Christopher L. Burton  
Vice President  
Harris Nuclear Plant  
Progress Energy Carolinas, Inc.  
Serial: HNP-08-075  
10 CFR 50.90

SHEARON HARRIS NUCLEAR POWER PLANT, UNIT 1  
DOCKET NO. 50-400/LICENSE NO. NPF-63  
REQUEST FOR LICENSE AMENDMENT  
TECHNICAL SPECIFICATIONS 5.6.1.3.a AND 5.6.1.3.b – INCORPORATION OF  
UPDATED CRITICALITY ANALYSES TO REFLECT REMOVAL OF CREDIT  
FOR BORAFLEX IN BWR SPENT FUEL POOL STORAGE RACKS

Subject: *Request for License Amendment for Technical Specification 5.6.1.3 to incorporate updated criticality analyses for BWR Boraflex storage racks.*

Figure 5.6-3

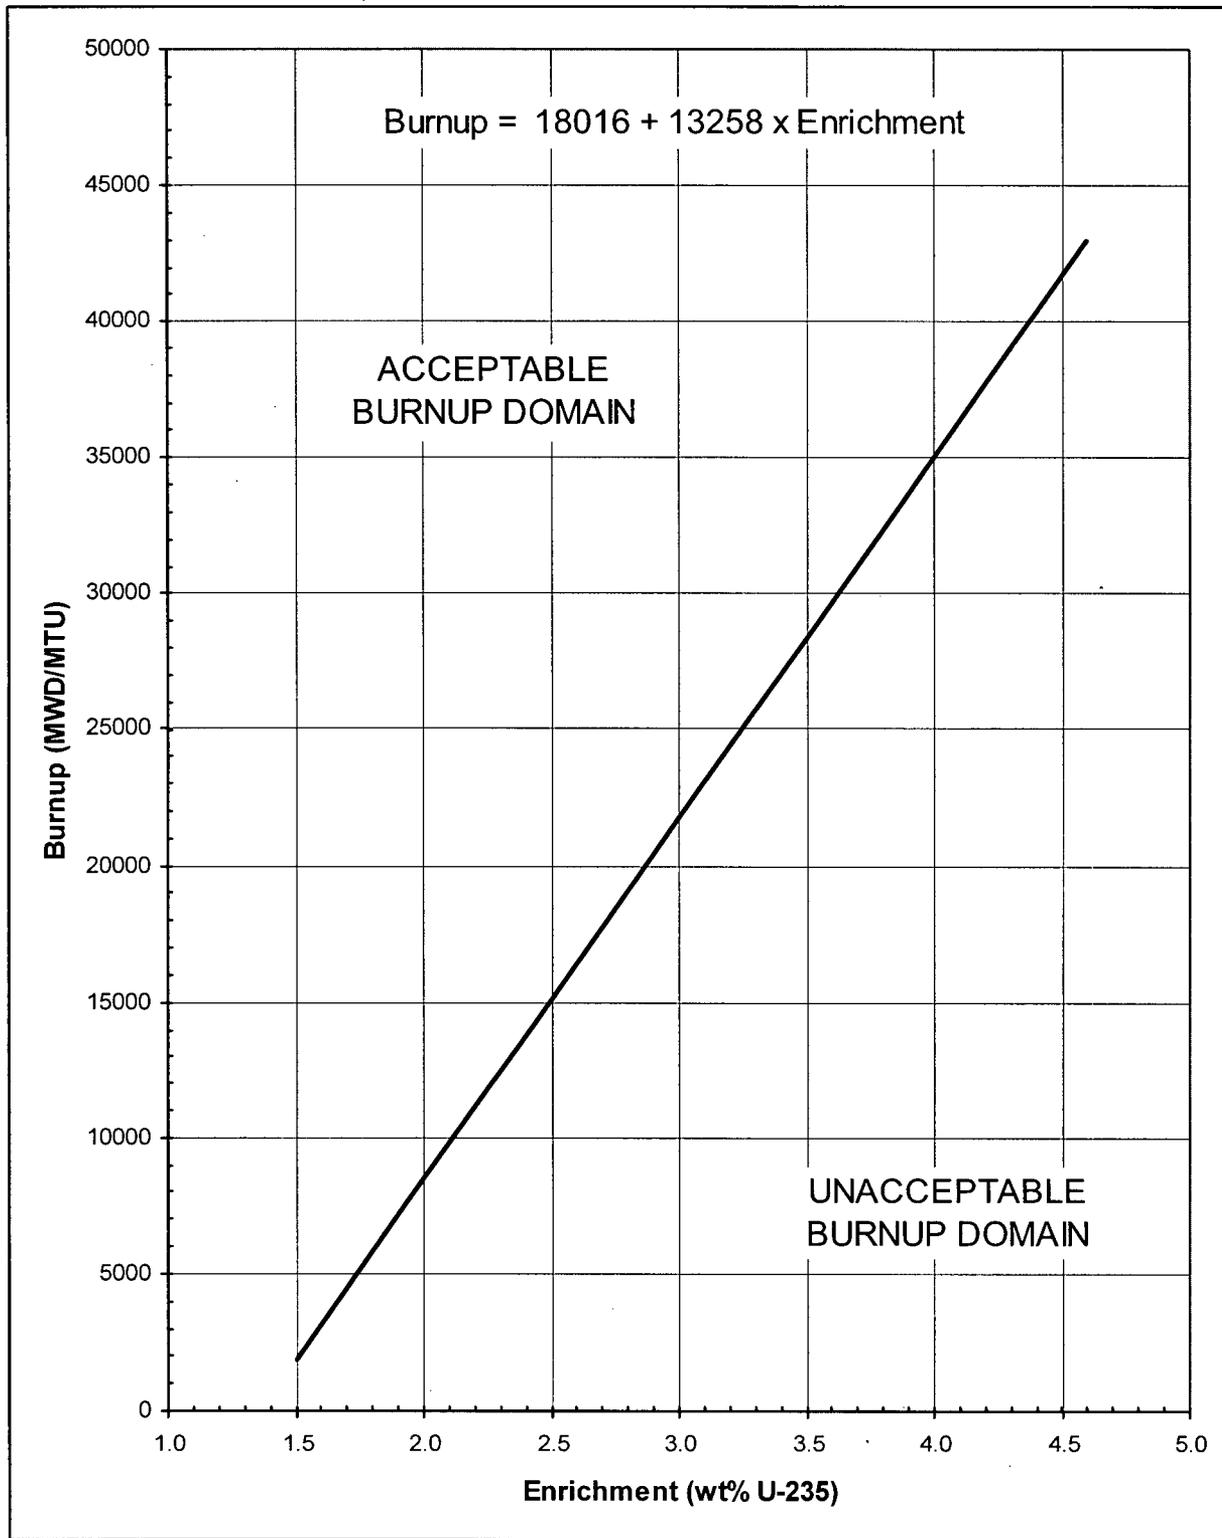
Additionally, new Figure 5.6-3, "Pools "A" and "B" Burnup versus Enrichment for BWR Boraflex Racks," is added to TS page 5-7e to define the BWR fuel that meets the requirements for unrestricted storage in the Boraflex racks in Pools A and B.

1.  $k_{\text{eff}}$  less than or equal to 0.95 if flooded with water borated to 2000 ppm.
2.  $k_{\text{eff}}$  less than 1.0 if flooded with unborated water.
3. Nominal 6.25 center-to-center spacing between fuel assemblies shall be maintained for fuel stored in the BWR racks.
4. BWR assemblies must be within the "acceptable range" of the burnup restriction shown in figure 5.6-3 prior to storage in a BWR Boraflex storage rack.

- 1) the fuel conforms to the enrichment-burnup limits for the spent fuel as shown in Figure 2, "Minimum Fuel Burnup for Acceptable Storage of Spent Fuel of Various Initial Planar Average Enrichments," of the Holtec report (incorporated into new TS Figure 5.6-3), and
- 2) a minimum of 300 ppm soluble boron is maintained.

Figure 5.6-3:

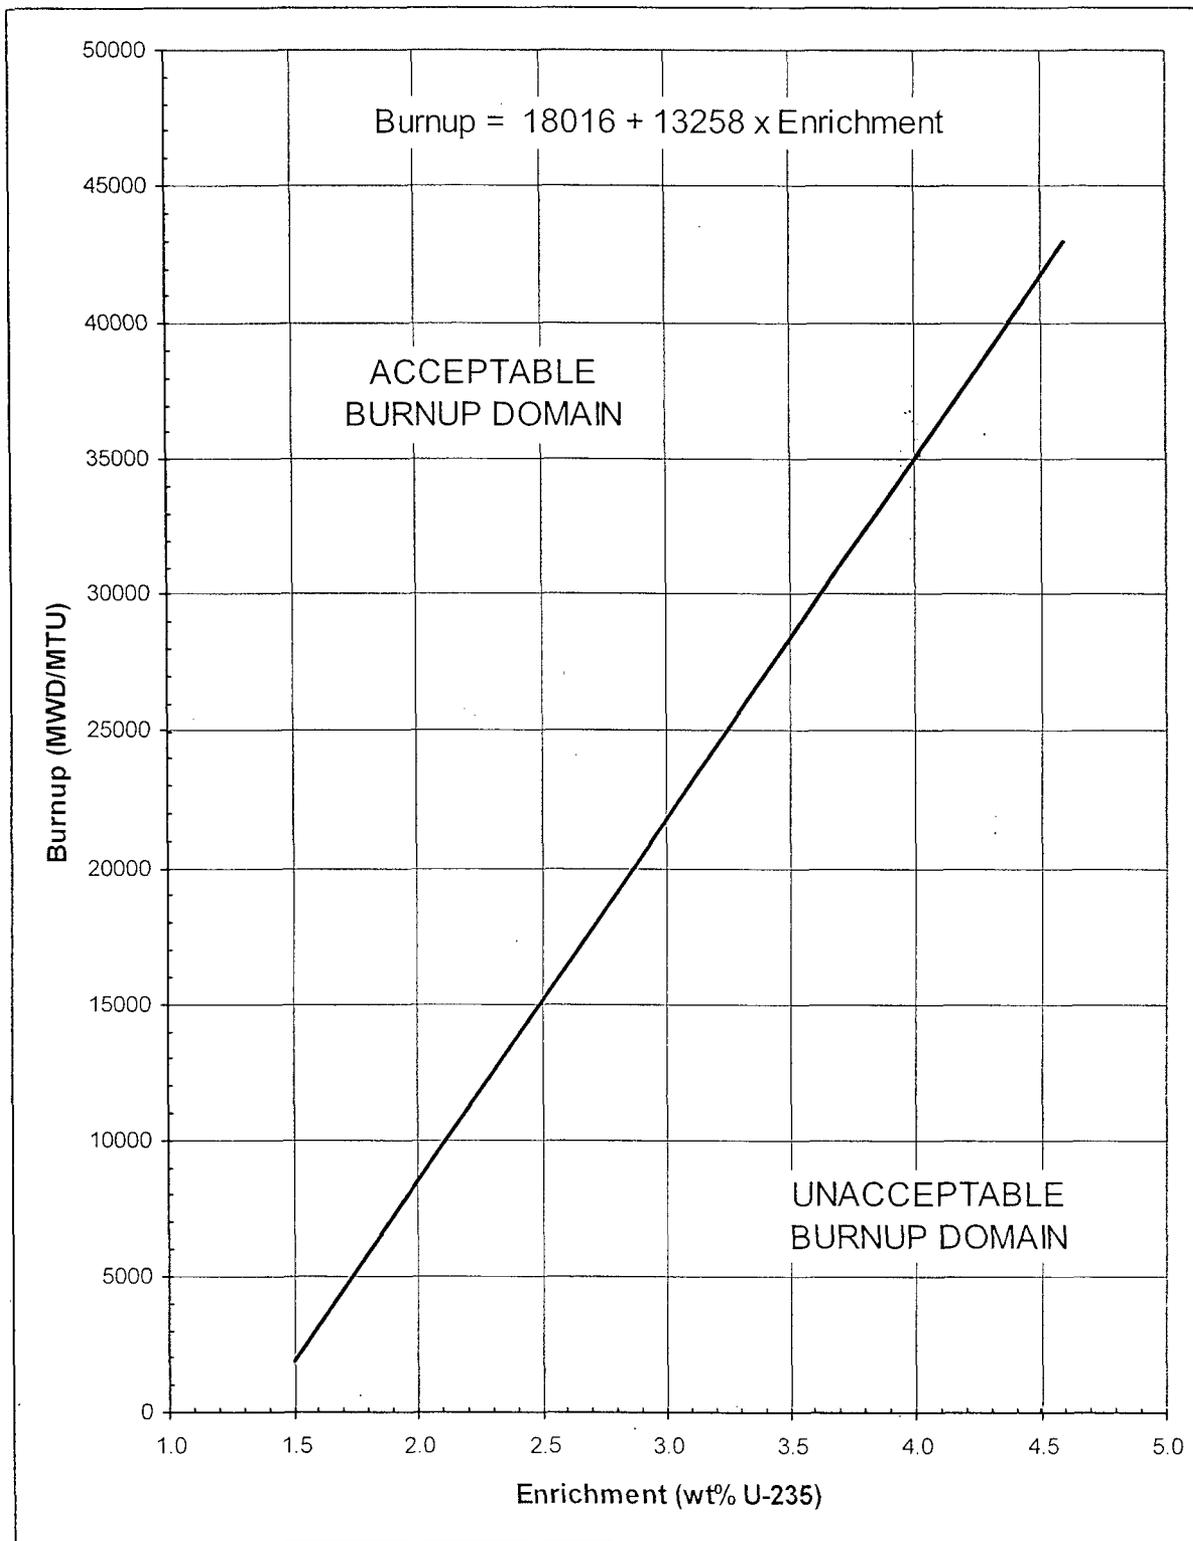
1.  $K_{\text{eff}}$  less than or equal to 0.95 if flooded with water borated to 2000 ppm.
2.  $K_{\text{eff}}$  less than 1.0 if flooded with unborated water.
3. Nominal 6.25 inch center-to-center spacing between fuel assemblies shall be maintained for fuel stored in the BWR racks.
4. BWR assemblies must be within the "acceptable range" of the burnup restriction shown in figure 5.6-3 prior to storage in a BWR Boraflex storage rack.
